# Appendix D – Recreational Resources Draft Study Report

Bad Creek Pumped Storage Project

January 4, 2024

Figure 4-2 Foothills Trail Conditions Assessment – Figure 1 of 19

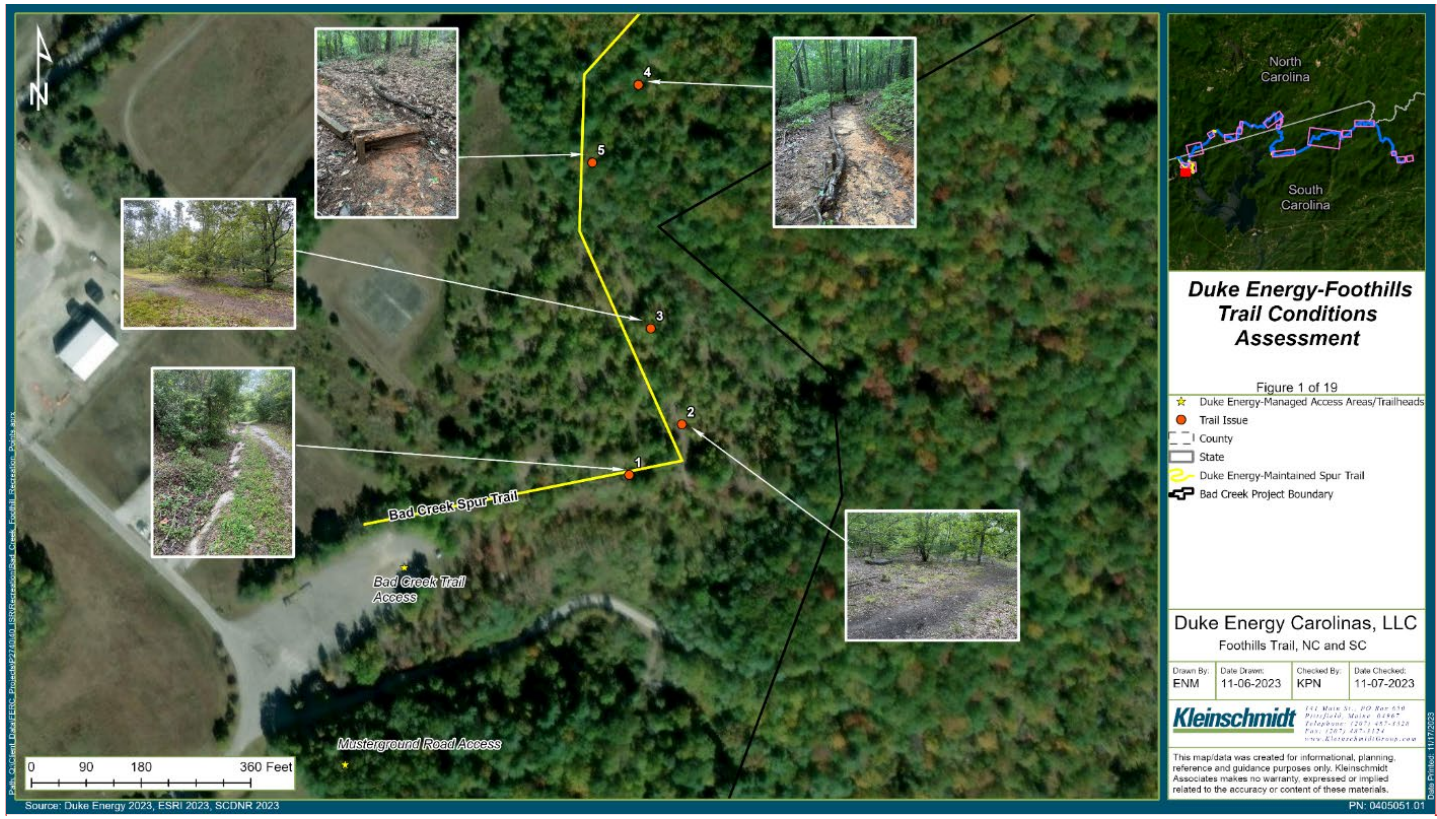
Commented [EM2]: Photo of Trail Issue #1 does not show the clogged culvert or downstream effects.

Figure 4-3 Foothills Trail Conditions Assessment – Figure 2 of 19

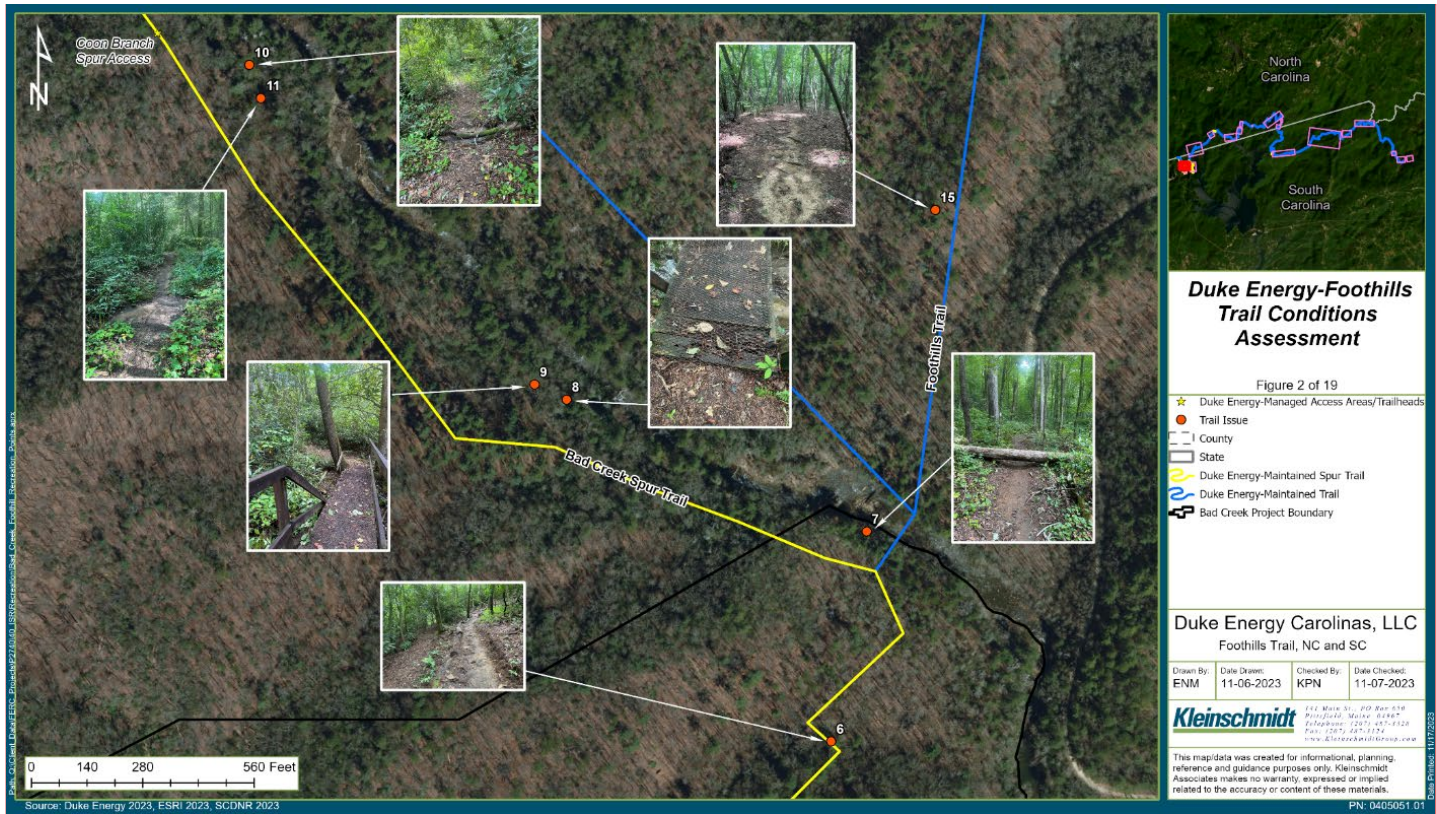
Commented [EM3]: Photo of Trail Issue #11 does not show the clogged culvert or downstream effects.
